Comment Letter I-91

Newland Sierra Project DEIR Comments

Tom Curriden – Starview Dr., Vista

DEIR Section 2.13 - Transportation and Traffic

FIGURE 2 - STEEP SLOPES

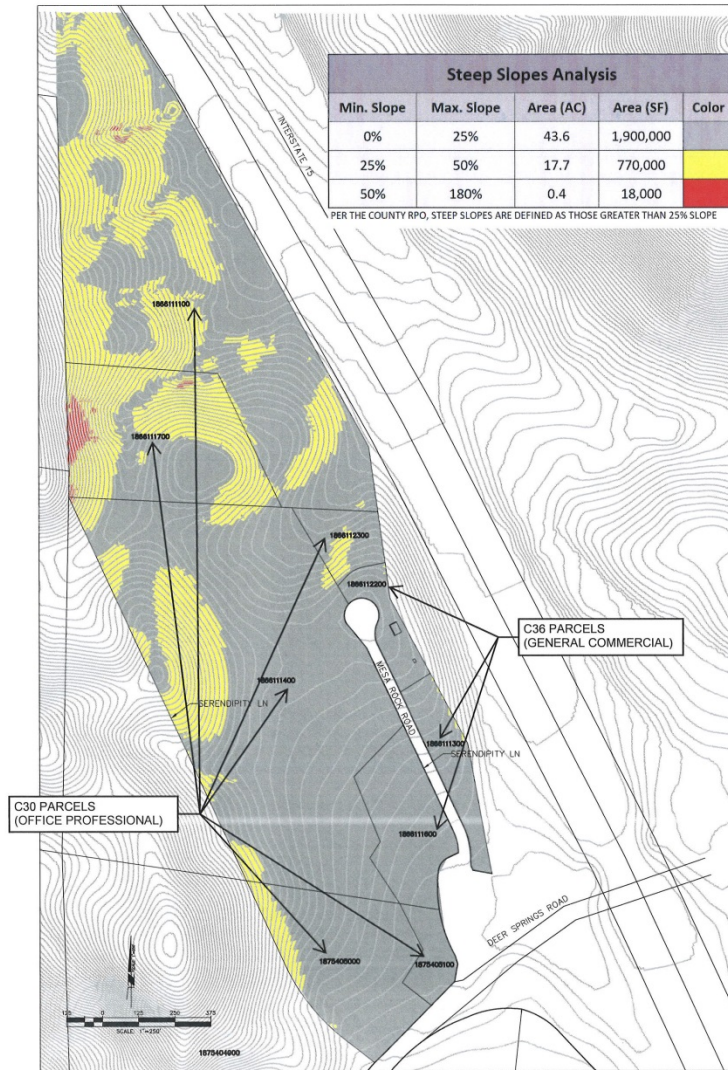
The Newland DEIR does not provide any detail on how the parcels would support over 2 million SF of development. Per the County Zoning ordinance, development on the parcels is limited to two-stories and 35-ft in total height, with setbacks up to 60-ft. In addition, much of the property lies on "steep slopes". Per the County Resource Protection Ordinance (RPO), steep slopes are defined as those natural slopes exceeding 25% in slope gradient and are a protected resource. Over 30% of the area of the commercial parcels qualifies as steep slopes per the RPO. As shown in **Figure 2**, the percent of steep slope area in several of the parcels exceeds 10% of the parcel area and requires an open space easement on the area of steep slopes (the yellow and red colored areas of Figure 2). Proposed development is not allowed to encroach more than 10% into an open space easement. In addition to steep slopes as a protected resource, the entire site consists of significant sloping that increases development costs and reduces development potential.

FIGURE 3 - DEVELOPABLE AREA

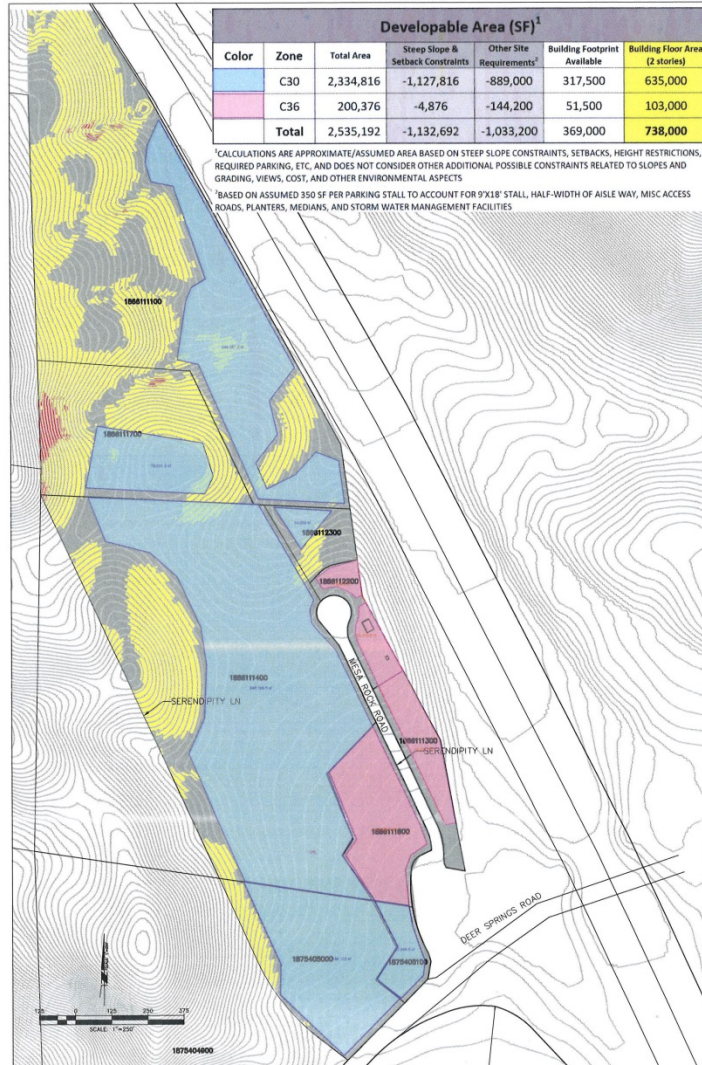
As shown in **Figure 3**, deducting for area of steep slopes and parking (at County ordinance rate of 4 stalls per thousand SF) yields a total developable building area available of 317,500 SF for C30 Office Professional and 51,500 SF for C36 General Commercial for a total of 369,000 SF. At 2 story height restriction, the total building square footage feasible is 635,000 SF for C30 Office Professional and

103,000 SF of C36 General Commercial, for a total building square footage of 738,000 SF¹. Note that there are additional potential constraints not taken into account that may further reduce feasible building square footage, including slope grading and earthwork, views, cost, economic viability, and other environmental factors.
